From: Nathan Wulf <nrwulf@yahoo.com>
To: "planning-commission@smcgov.org" <planning-commission@smcgov.org>
CC: "jcastaneda@smcgov.org" <jcastaneda@smcgov.org>, "dpine@smcgov.org" <dpine@smcgov.org>, "cgroom@smcgov.org" <cgroom@smcgov.org>, Craig Nishizaki <watertankhill2013@gmail.com>
Date: 1/28/2015 3:43 PM
Subject: Ascension Heights Development: Concerned parent and home owner

From: Oksana Mukha <oksanarn@sbcglobal.net>
To: "Planning-Commission@smcgov.org" <Planning-Commission@smcgov.org>
CC: "jcastaneda@smcgov.org" <jcastaneda@smcgov.org>, "dpine@smcgov.org" <dpine@smcgov.org>, "cgroom@smcgov.org" <cgroom@smcgov.org>, "watertankhill2013@gmail.com" <watertankhill2013@gmail.com>
Date: 1/28/2015 4:45 PM
Subject: Ascension Heights Development Concerns

The following represent area community comments and provide factual data for our request to the Planning Commission to Revise and Recirculate the DEIR, Ascension Heights Subdivision Project.

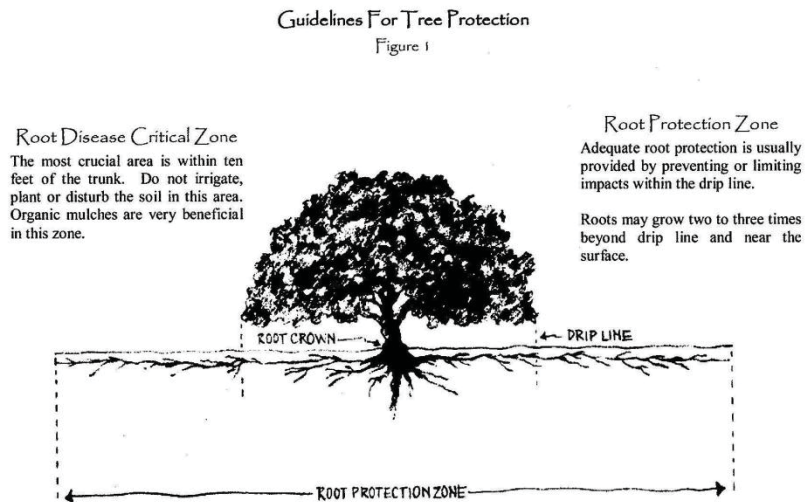
The low-growing branch structure of each tree, in the southern direction, toward the proposed development site, absolutely prohibits encroachment into the 18 foot wide fenced zone along the 80 foot southern aspect of the property. This area is the structural root zone, where encroachment and root cutting could destabilize the trees and predispose wind-throw topping in the direction of the existing home. Vertical clearance is minimal in this area due to large low limbs, so equipment use and building of structures is impossible without incurring significant harm to the trees.

The existing wood and wire fence, which is located at approximately 18 feet to the south of the tree trunks, should represent a boundary for an absolute non-intrusion zone for any grading and construction activity. A larger zone in that direction, the entire 40-50 foot linear measurement under the foliar canopy, to the south of each tree should be considered the minimal tree protection zone, in order to avoid physiological harm from disturbance of the soil and the absorbing root system.

Area of sloping terrain to the south, under low branching limb structures. Encroachment and root disturbance in this area would severely harm, destabilize or kill these trees.

Third, soil stability and land slides.

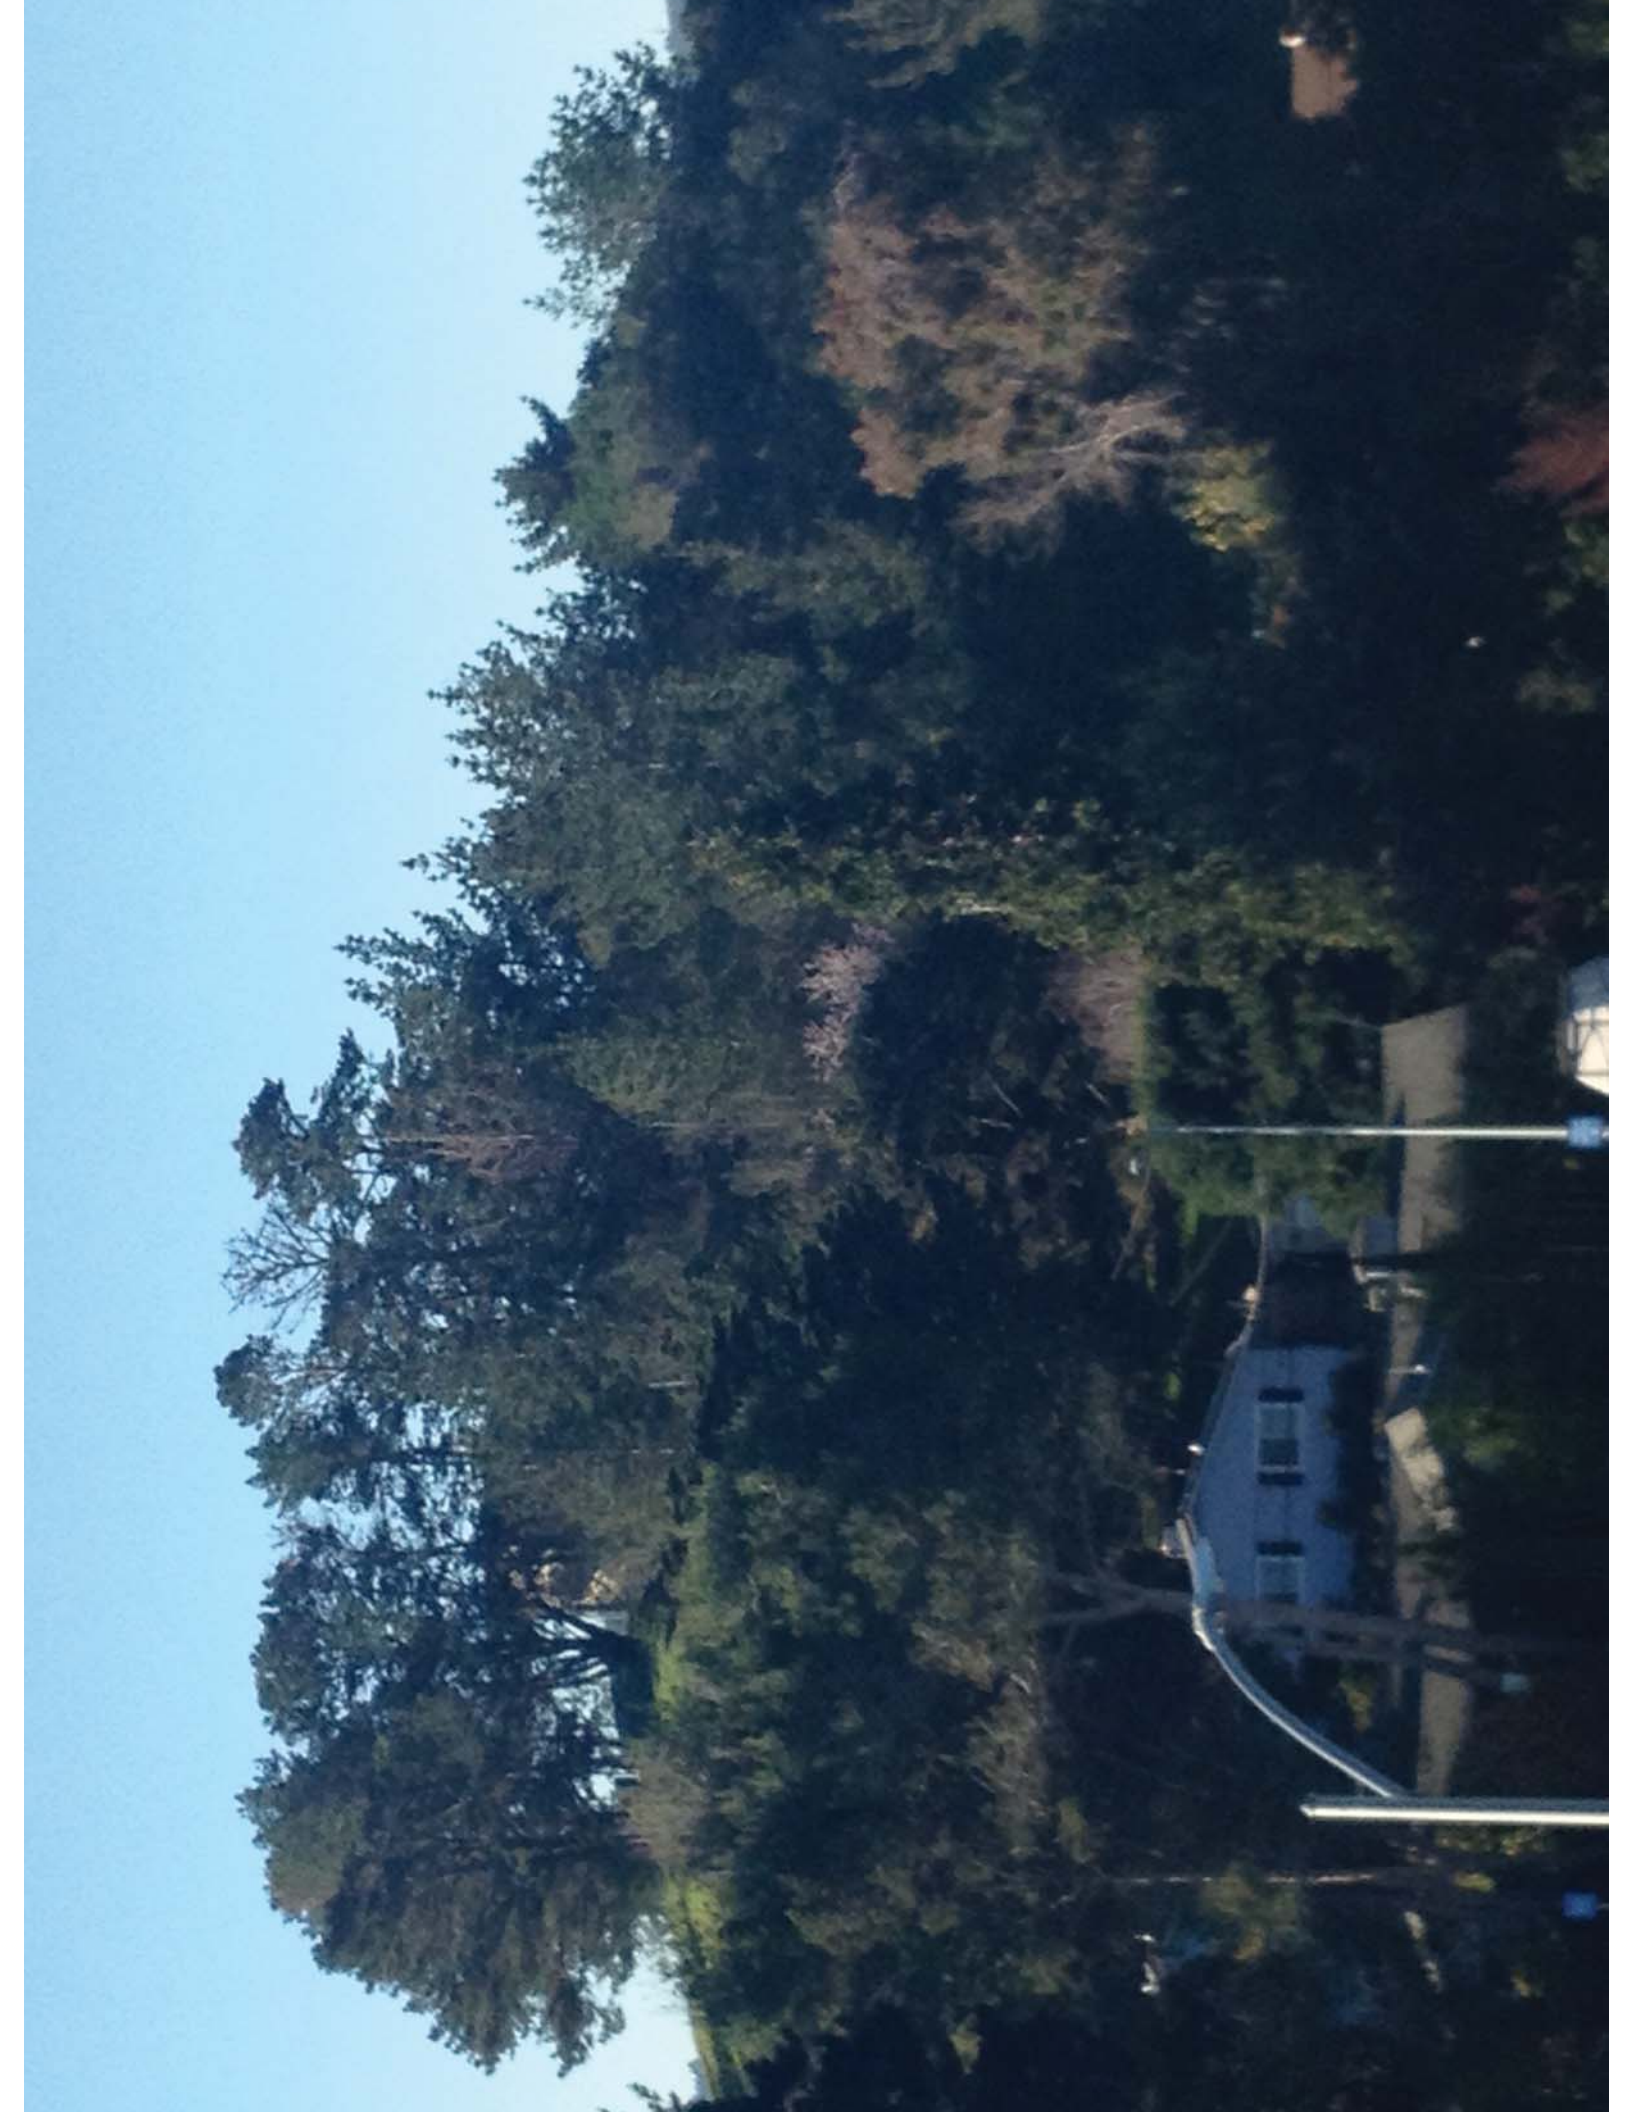
The soil expert testified that there were no slide issues because the hill is bedrock just below the surface. He also testified that the bedrock is from 1 to seven feet thick. If the bedrock is removed in the leveling and grading process, it seems to me that a land slide problem is being created where none previously existed.

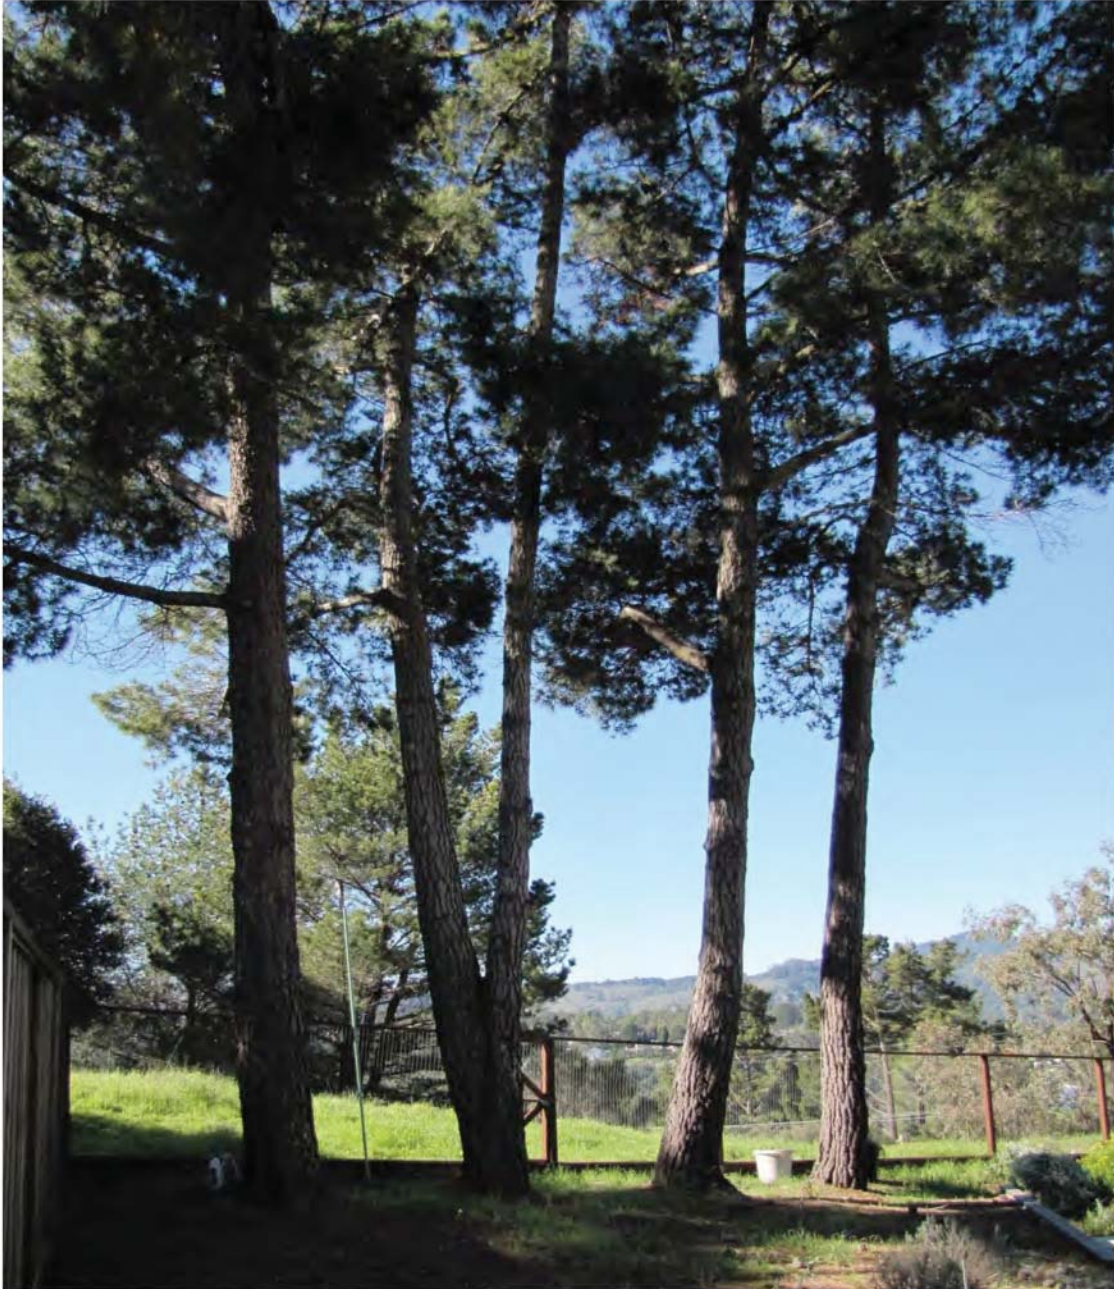
- 1) Cars coming down the new roadway will be pointing their headlights directly into my master bedroom (see blue line). See blue line pointing into bedroom. Mature trees, bushes or other means should be a requirement on the planned roadway sides to prevent light from shining into my bedroom.

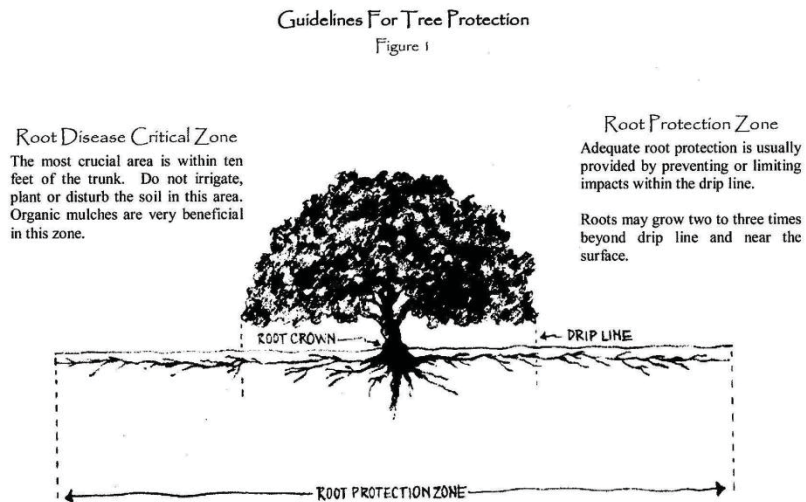
Fifty percent of the critical root zone of these trees, exists in the south-western direction, on the property of the proposed development site, between the tree trunks and the existing access road into the "Water Tank Hill" property. The area along the fence-line and on the other side of the fence, up to the access road is the most important structural root zone, where encroachment and root cutting could destabilize the trees and predispose wind-throw toppling in the direction of the existing home.

The north-eastern side of the access road should represent a boundary for an absolute non-intrusion zone for any grading, excavation and construction activity, in order to avoid structural and physiological harm to the tree root systems.

***Area of sloping terrain to the southwest of the subject trees.
Encroachment and root disturbance in this area would severely harm,
destabilize or kill these trees.***
